OCONEE NUCLEAR STATION, UNIT 1

AMENDMENT TO FACILITY OPERATING LICENSE

ATTACHMENT TO LICENSE AMENDMENTS

Revise Appendix A as follows:

FIGURE 6.1-1 | 14/9/1

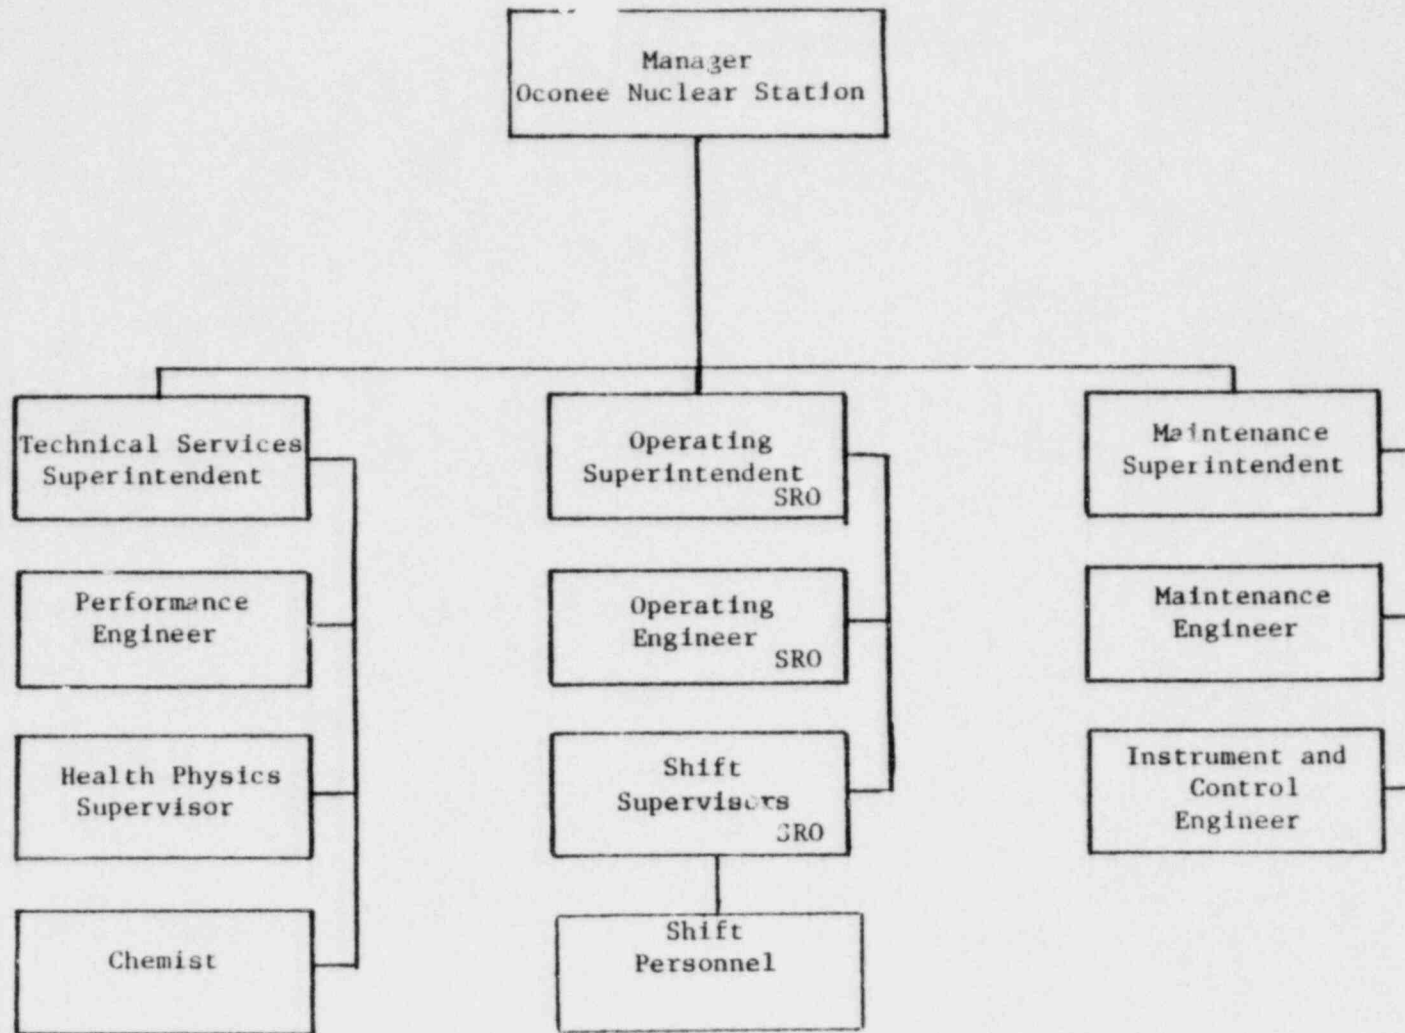
6.1.1.3 The station organization for Operations, Technical Services, and Maintenance shall be functionally as shown in Figure 6.1-1. Minimum operating shift requirements are specified in Table 6.1-1.

FIGURE 6.1-2 | 14/9/1

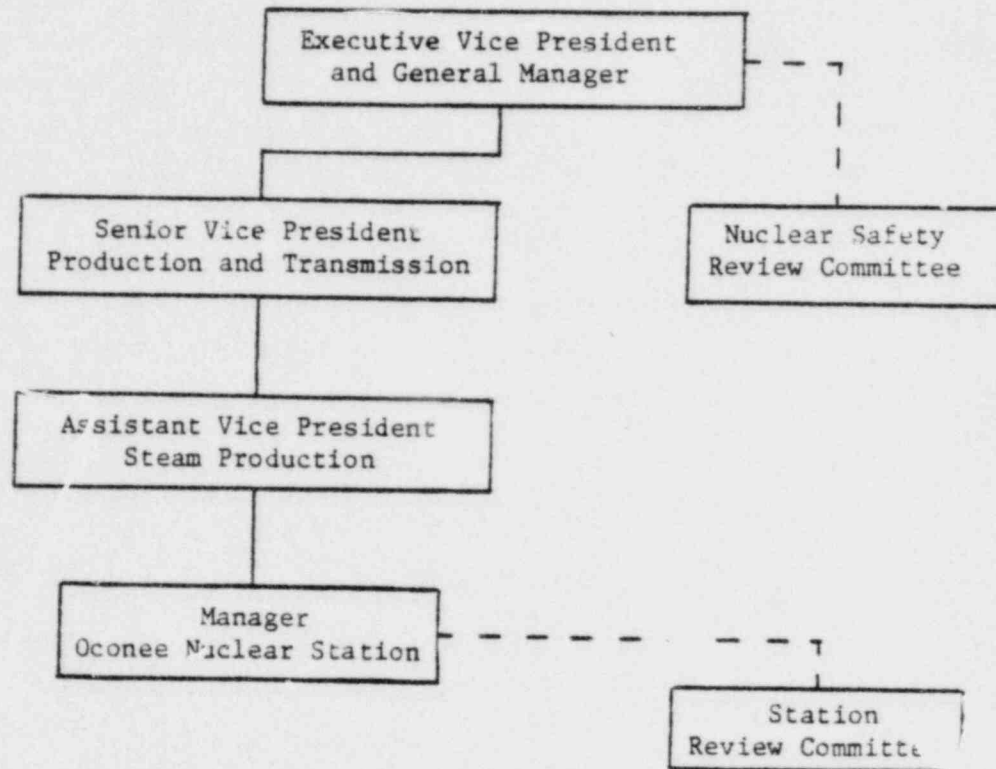
6.1.1.2 In all matters pertaining to actual operation and maintenance and to these Technical Specifications, the station Manager shall report to and be directly responsible to the Assistant Vice President, Steam Production. The organization is shown in Figure 6.1-2.

In matters of nuclear safety and radiation exposure, review and audit of station operation, maintenance, and technical matters shall be provided by two committees as follows: (Reference Figure 6.1-2)
